## Product Change Notification / LIAL-07RPOQ740

CCB 5135 Final Notice: Qualification of a new lead frame with more Ag area on DAP surface prep for selected KSZ8081 and KSZ8091 device families available in 32L VQFN (5x5x0.9mm) package assembled at MTAI assembly site.

LIAL-07RPOQ740 - CCB 5135 Final Notice: Qualification of a new lead frame with more Ag area on DAP surface prep for selected KSZ8081 and KSZ8091 device families available in 32L VQFN (5x5x0.9mm) package assembled at MTAI assembly site.

## Pre Change

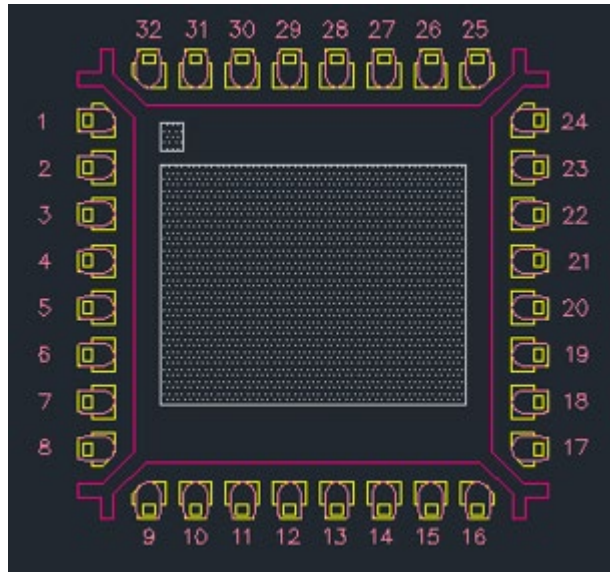
Lead frame DAP surface prep

Ag selective plating

## Post Change

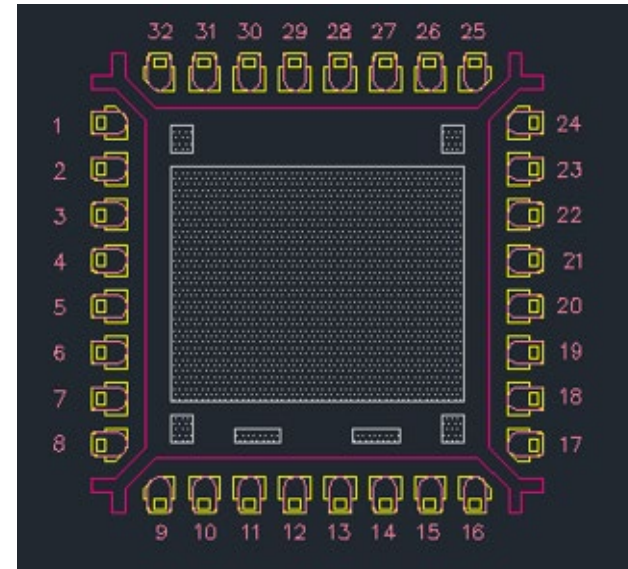
Lead frame DAP surface prep

Ag selective plating  
(Add more Ag area)
